Approved Development Application No.: **07-04-2012**

Project: **GG ESPRESSO BAR OLYMPIC PARK**  
Address: **CNR AUSTRALIA AVENUE & PARK VIEW DRIVE, OLYMPIC PARK**

**GENERAL LAYOUT**

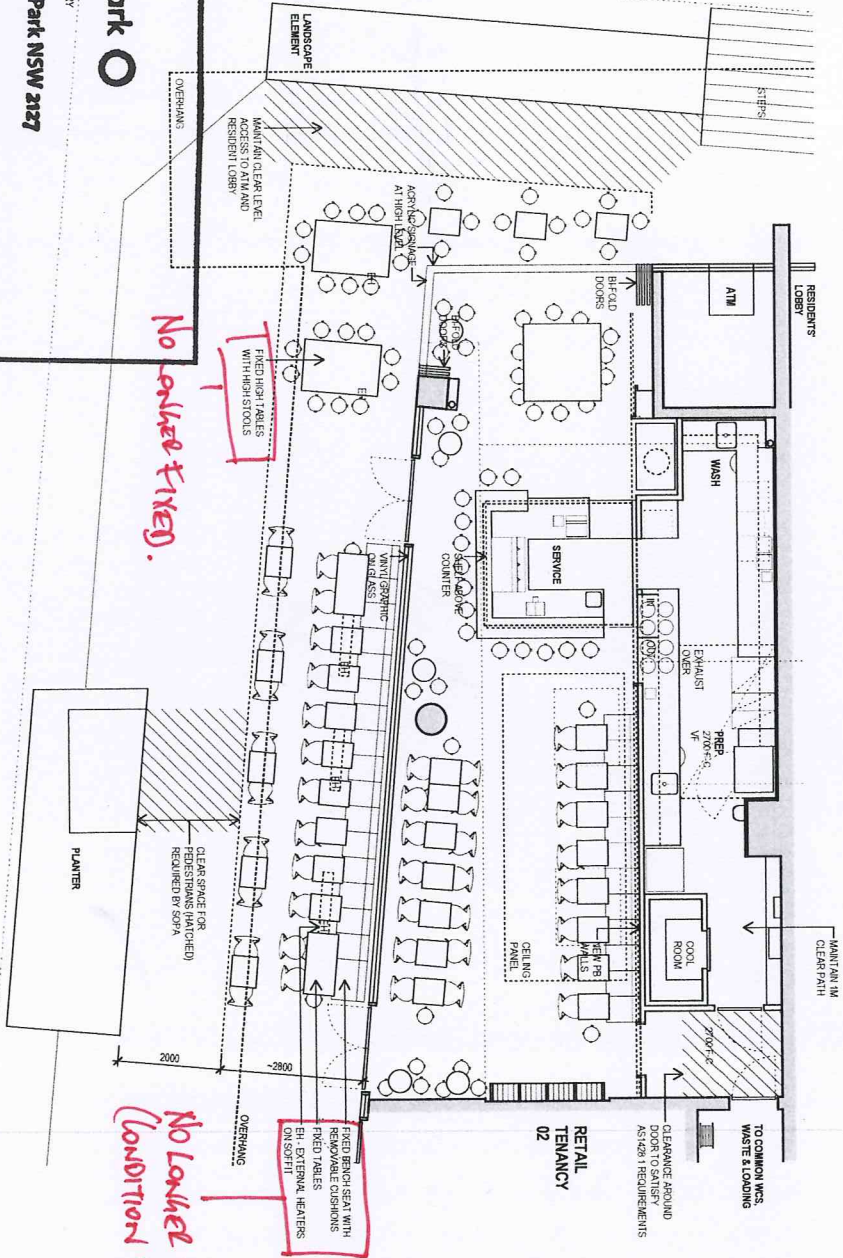
*No Lounge Fixed.*

*No Lounge Fixed. (Condition E9)*

Dwg Title INTERNAL ELEVATION

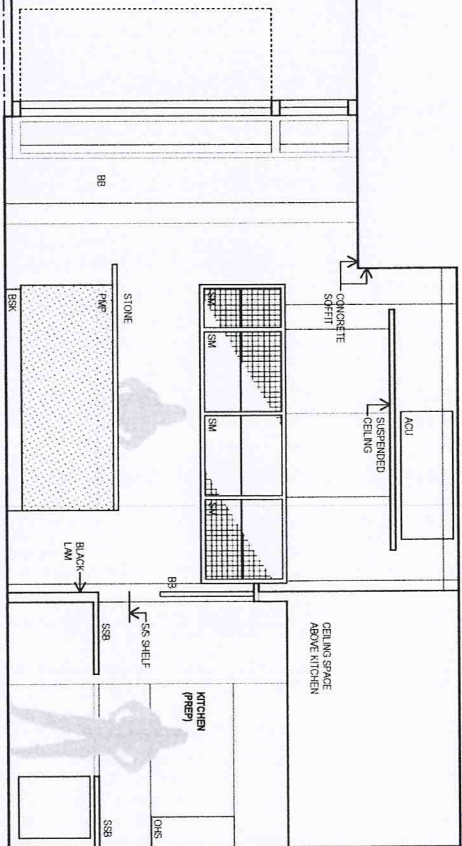
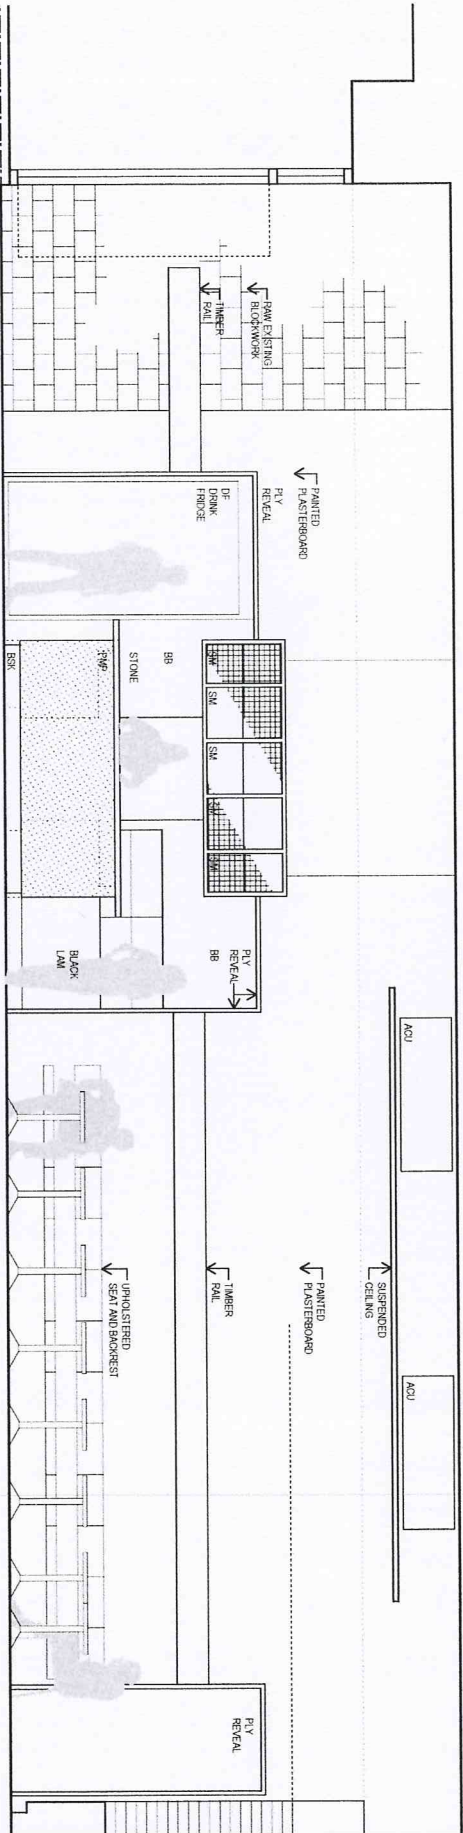
\*confirm width  
of passage
